Truro Board of Health

Tuesday January 17, 2023
Remote Meeting- 4:30 PM

Proposed Sewage Disposal System 108 Slough Pond Rd., Truro, MA	
Prepared for: Jeff Halpin, Tr. 104 Irving St. Cambridge, MA 02138	CSN ENGINEERING P.O. Box 201 Brewster, MA 02631 Phone: (508) 274-7347
DATE: 1/02/2022	SCALE: AS SHOWN
DESIGN: LIC	CHECK: RM
JOB NO: 2021316

To: Truro Board of Health
From: Emily Beebe, Health & Conservation Agent
Date: Jan 13, 2023
Re: January 17 meeting: septic upgrades- review notes

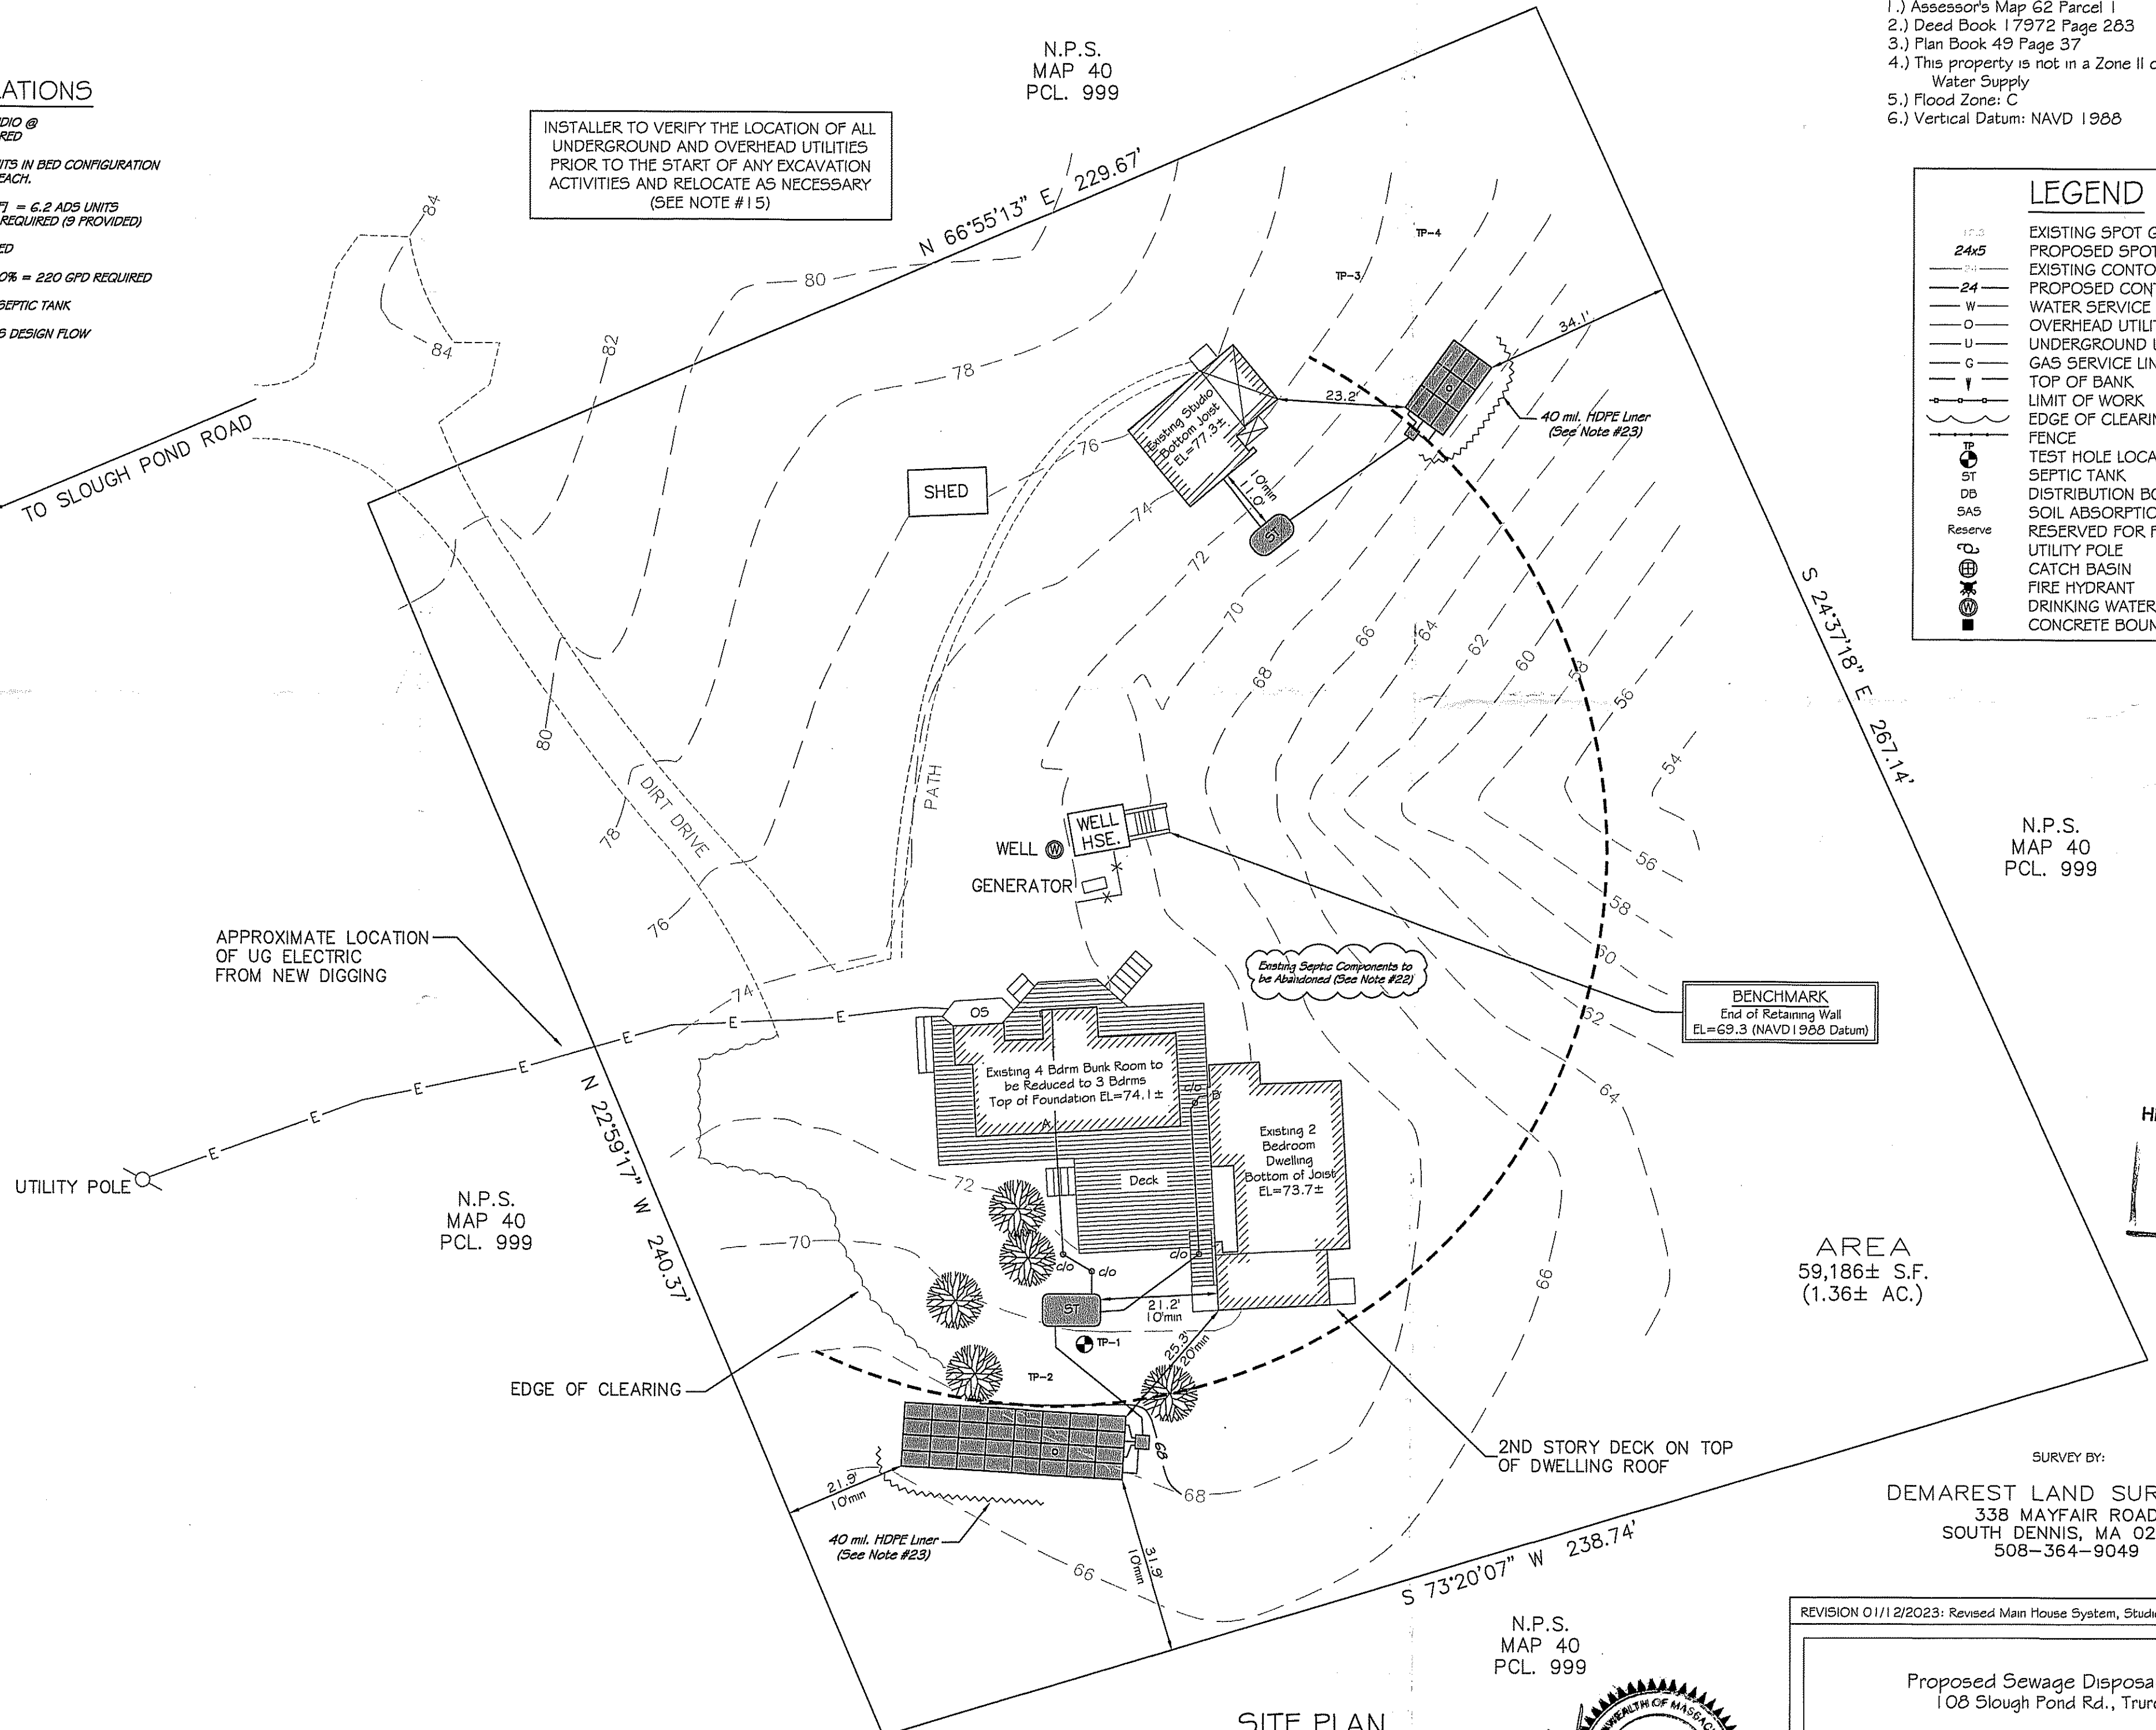
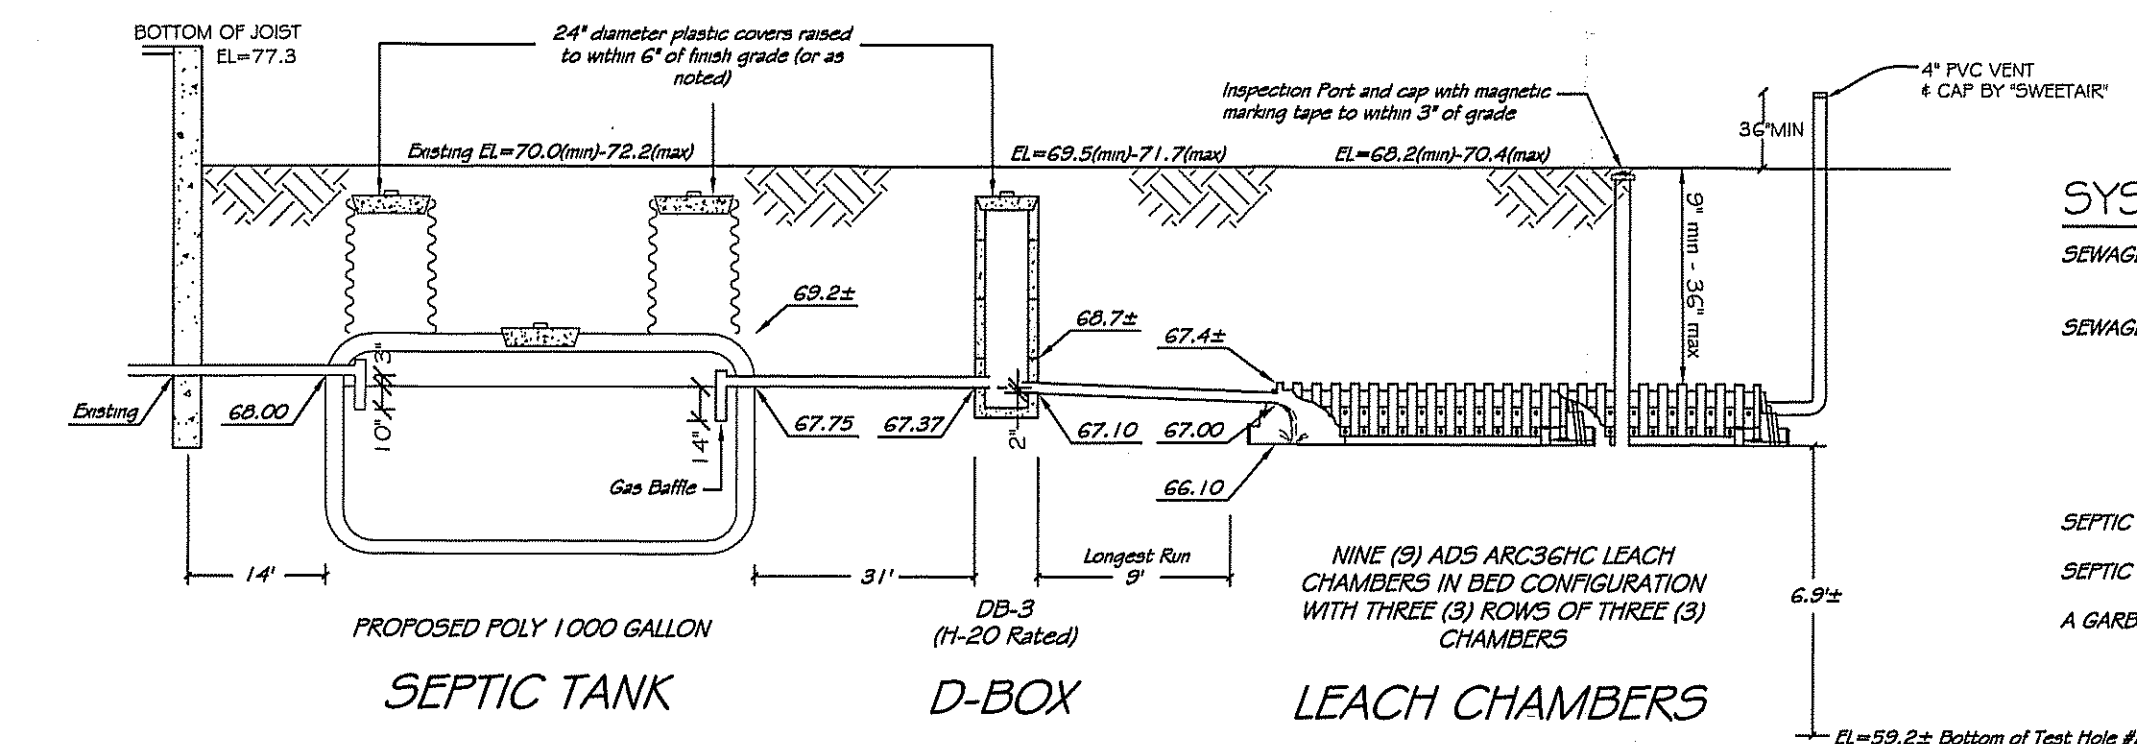
108 Slough Pond Road Road

This septic upgrade will serve 3 existing structures with a total of 7 bedrooms on this 59,186 sf property.

- We find no permit trail for 1-Bedroom that was constructed in 2004; and the owners are aware that the legal bedroom count for the property is 6 bedrooms. They will submit a floor plan sketch showing where changes in the layout will be made to reduce the bedroom count to 6.

- The existing use on a lot of this size triggers the use of I/A technology under TBoH regulations. **A variance to this requirement is being requested.**

- The property is served by composting toilets; greywater will be disposed of in 2 title 5 systems ,
- The use of composters is a suitable alternative to using I/A treatment, but this could easily be changed to traditional fixtures if the property is sold, therefore we recommend a deed restriction be put in place denoting the presence of composters and upon transfer the matter return to the BoH to address concerns about what happens to the composters if the property is sold, or at such time as the composters are not used, relative to the TBoH requiring I/A.

- Approval of the variance is recommended with conditions:
 1. A plumber should be hired by the owner to apply for after the fact permits for the composting units. These composters would be inspected by the plumbing inspector, and any issues regarding safety, etc. would be properly addressed through this process.

2. A deed restriction be crafted denoting the presence of composters and upon transfer the matter return to the BoH.
